# Service News

## Prevention of F.O. Solenoid Valve Installation Mistake

**Solenoid valve of Normally Open (N.O.) is painted red.**

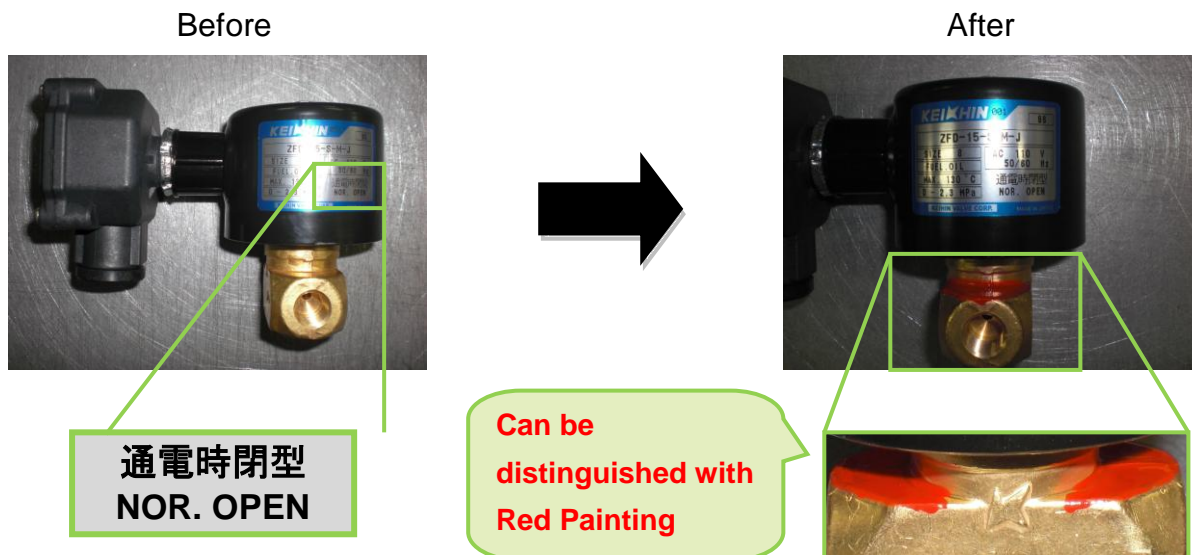
There was serious accident before that Normally Open (N.O.) and Normally Close (N.C.) was installed wrongly on type HB boiler at F.O. solenoid valve replacement. Although name plate is printed in both of Japanese and English, there are some cases that it can not be distinguished because coil part with name plate is taken off at installation and replacement, or difference of appearance can not be noticed and it is installed wrongly.

As prevention of these trouble, body of Normally Open (N.O.) is painted **Red** to distinguish Normally Open (N.O.) and Normally Close (N.C.) on valve side.

Solenoid Valve Type	Old Parts Code	New Parts Code	Power Supply
ZFD-15-S-M-J	0000-000-H853-0	0000-AKD-0613-0	AC110V
	0000-AA7-0704-0	0000-AKD-0614-0	AC220V

※Solenoid Valve (Type;ZFD-15-H-J) of Normally Close (N.C.) has no change.

We would like you to order spare parts with new parts code.
